RE: Jeam Investments LLC
Premises: 401 Grand Avenue
Leonia, NJ 07605
Block: 803 Lot: 38 Calendar No. 2018-13

**RESOLUTION
LEONIA PLANNING BOARD
APPLICATION OF JEAM INVESTMENTS, LLC**

***NOTICE OF APPROVAL
LEONIA PLANNING BOARD
APPLICATION OF JEAM INVEST-
MENTS, LLC
401 Grand Avenue
Leonía, New Jersey
Block: 803 Lot: 38
Calendar No. 2018-13**

**REVISED ZONING DATUM
DATED MARCH 14, 2020**

Zoning Plan & Site Plan

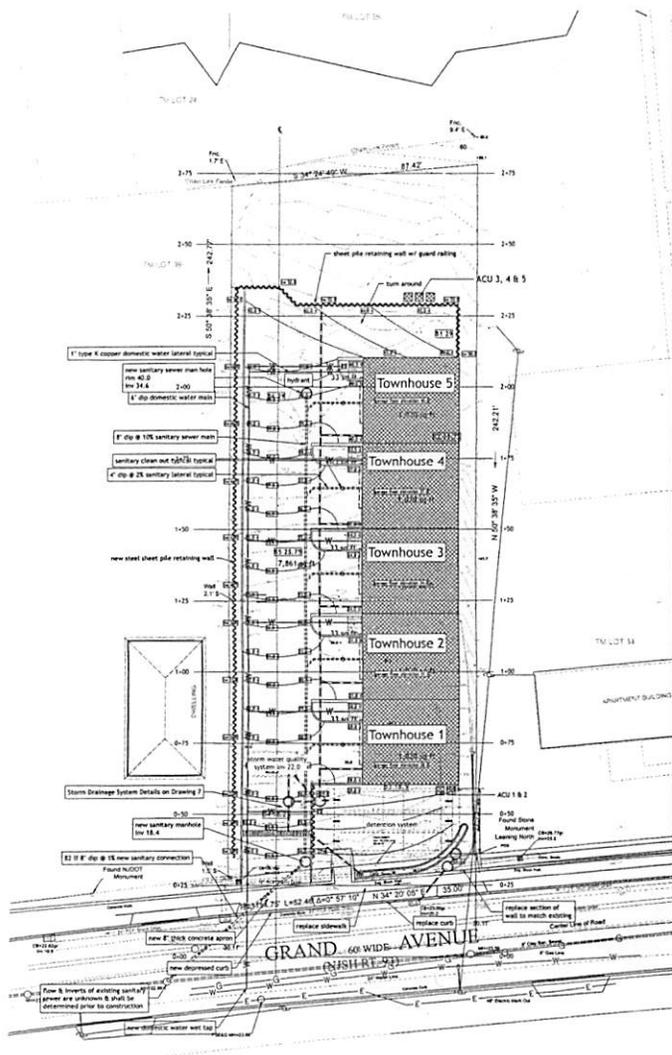
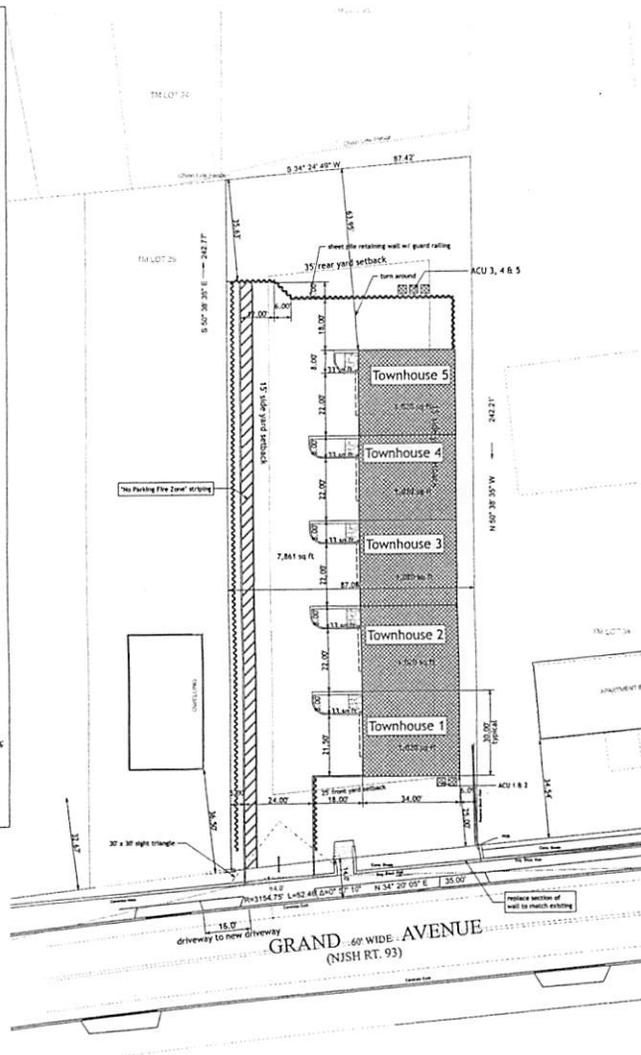
misstated at 4,800 square feet. The difference in the building coverage as approved was 22.74% and the revised plan reflects 24.16%; Lot coverage approved was 39.07% versus the revised plan of 37.65% and total coverage approved was 60.93% versus the revised plan 63.35%.

Attached to this memorandum is the revised zoning schedule prepared by John Gilchrist, R.A. which reflects the correct coverage data (see Exhibit "C" Revised Zoning Datum dated March 14, 2020). The Board will note that the maximum building coverage is reflected at 24.16%, the landscape and open space at 37.65%, and the total coverage at 62.35%.

A review was completed comparing the board approved plan date 1-11-19 to the new revised plan dated 3-14-20. Please note your plan changes;

Building coverage
Approved 22.74%.
Revised plan 24.16%

Lot Coverage
Approved 39.07%
New plan 37.65%

Total coverage
Approved 60.93%
New plan 63.35%.

Owner:
 Jeam Investments LLC
 contract purchaser
 631 E Palisades Avenue
 Englewood Cliffs NJ 07632
 8-3-20 revise zoning schedule J.J.G.
